Roof Framing PLAN

D & CYNTHIA FRANKE SOUTHERN APPROACHES UNIT ONE LAKE CITY FLORIDA 32025

JOB NUMBER 050608

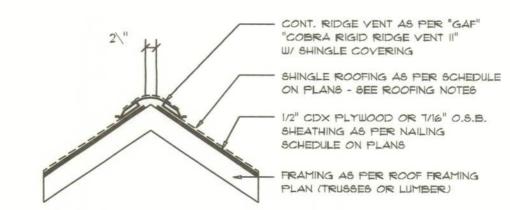
R-5 MOVE ALL WENTS AND OTHER ROOF PENETRATIONS TO REAR
